An Alternative Feedback Network for the Single Ended F5

XEN Audio

September 2021

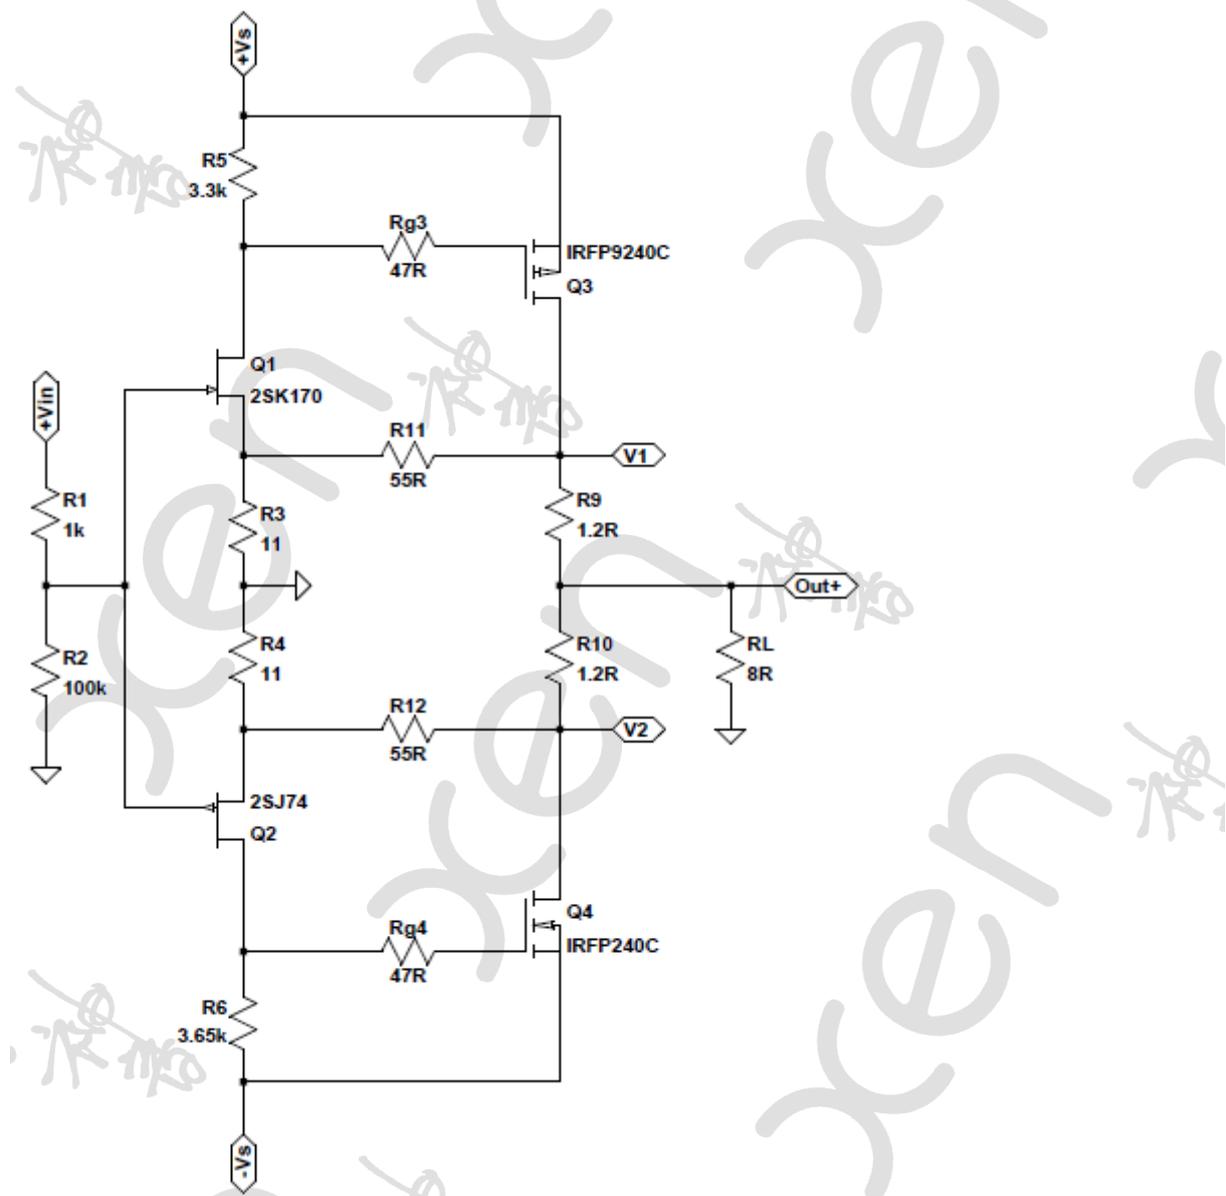
Earlier, Lynn Quam posted an alternative feedback circuit for the standard F5 power amplifier^[1], which I thought was really clever. But he asserted that all he wanted was to achieve bias stabilisation, so that he could get rid of the MOSFET source resistors.

We set up a Spice model of his circuit and just look at DC operating point first. After setting the MOSFET bias to about 1.27A, we deliberately add an additional current of 100mA in parallel across Q3, to simulate the MOSFET heating up with a positive tempco. In the original circuit, without the Quam resistors (R9,10) one can see that the bias of Q4 will increase by 50mA, and the DC offset goes up by 11mV. With the Quam circuit, both DC offset and bias remains largely unchanged. So it works as intended. Good news.

R9,10 sense the respective drain current of Q3,4, and fed that back to the front end via the NFB network. An increase in bias current of Q3, for example, will lift the DC voltage at the Source of Q1, and hence reduce its current. This, in turn, reduces the voltage across the drain resistor R5, which then reduces the bias of Q3. It therefore forms a feedback loop to regulated the bias current. The degree of regulation depends of course on this loop gain. The higher the value of R9, the better the bias stability.

So why not use a much larger value for R9,10 ? Well, R9,10 to the output is outside the feedback loop of the amplifier. A large value for them will not only increase the output impedance, but also reduce gain, as seen by the external load RL.

In addition to that, R9,10 also have other effects. Since we are talking about a Class A amplifier, there is a constant bias of say >1A. Even with no signal, the constant bias will generate a DC voltage at the source of the input JFETs (Q1,2), resulting in significant reduction in bias of the front end. The drain resistors will have to be increased to compensate for that, and the balance of the gain structure between first and second stage will change as a result. It does not have to be a bad thing, as loop gain is likely to increase as a whole.

Those sensing resistor not only work in DC, but also in AC. One can argue that they can be each paralleled with a 22,000 μ F electrolytics to let AC through. But if we don't, as shown in his circuit, then they also have an impact on the AC performance of the amplifier.

Let's assume that the top and the bottom halves of the F5 is completely symmetrical, i.e. the "push" current of one half is exactly equal and opposite to the "pull" current of the other half. Or, the amplifier has no even harmonic distortion into a perfectly linear load impedance. In that case, the total voltage across R9,10 will remain constant, but swings relative to Gnd with the output voltage. They behave as if they do not exist for AC feedback, other than the above-mentioned DC shift for the front end and the increased effective RL. If, however, the two halves are not perfectly symmetrical, and there is some even order harmonics, then the voltage across R9,10 will not remain constant, as can be seen in the simulation. This variation is actually a measure of those distortions, which are now being fed back to the frontend through the normal NFB network. And as you can see, when compared with the standard F5, the second harmonics is being reduced by some 6dB. Not bad for just 2 extra resistors.

Why does it not cancel the second harmonics by some 20dB, like in a F5X ? The value of R9,10 in parallel is only a fraction of the load impedance. So the distortion sensing is already attenuated by that ratio. On top of that, the reduced bias of the frontend will also lower its transconductance and hence increase the first stage distortion. There is a sweet spot somewhere, which is, unfortunately, load dependent.
